*Our Nation's Energy Future Coalition (ONE Future)
1200 Smith Street, Suite 900,
Houston, TX 77002
832-397-8501*

Re: ONE Future Comments on Revisions Under Consideration for CO₂ Emissions from Natural Gas and Petroleum Systems in the 1990-2016 GHG Inventory

Figure 1. 2015 GHGRP Reported CO₂ Emissions from Flaring at Gas Processing Plants

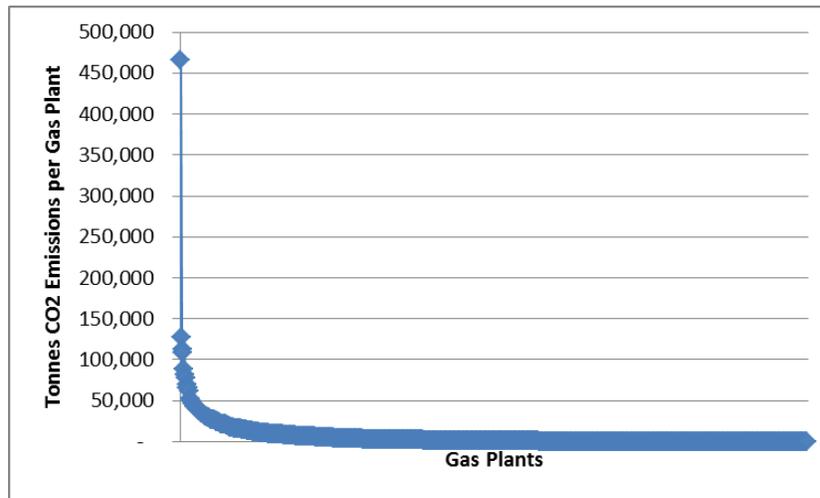
In addition, scatter plots of emissions data reveal data outliers that should be investigated. For example, Figure 1 plots CO₂ emissions reported for 2015 from flaring at gas plants. The highest emission gas plant represents almost 11% of the total national CO₂ emissions from flaring at gas processing facilities.

ONE Future recommends that EPA develop a transparent procedure for screening GHGRP data for errors and inconsistencies, that EPA identify which data points have quality issues and that EPA exclude data points with obvious errors or inconsistencies until reporters can provide corrected information. These steps are necessary to ensure that erroneous information is not used in developing national GHG emission estimates.

Figure 2. 2015 GHGRP Reported Volume of Gas to Flare at Gas Processing Plants

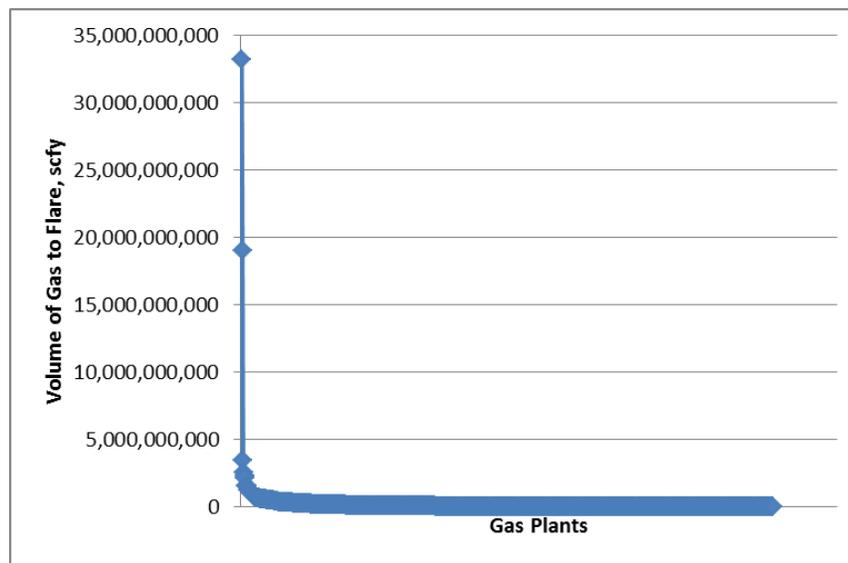
Figure 2 plots the reporting volumes of gas sent to flares at gas processing facilities, as reported through the GHGRP for 2015. The top two data points in this figure report volumes of gas to flare that are an order of magnitude higher than the next highest data point. These flare volumes are larger than the total volumes of gas processed for most states.
